New XT Series Fuel Tank

The new 14 065 63-S fuel tank utilizes a material that addresses isolated incidents of nylon leaching into the fuel system (previously covered in the 2013-2014 Service Update Book), as well as improved cap installation and fit.

Figure 1. Old Tank 14 065 56-S.

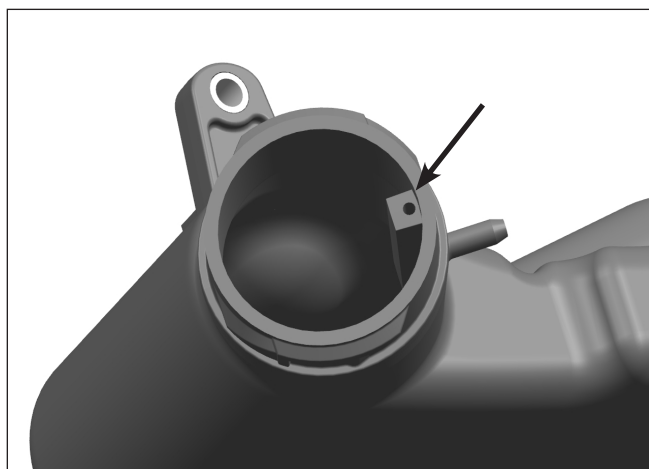
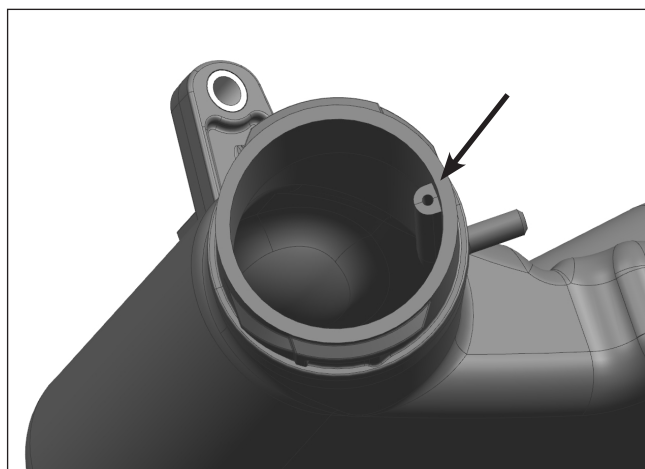
This new tank should be used as the replacement for any such reports and can be identified visually by the round shape of the internal tank neck feature shown below.

If you have inventory of the 14 065 56-S fuel tank, please contact your Central Distributor for a new replacement.
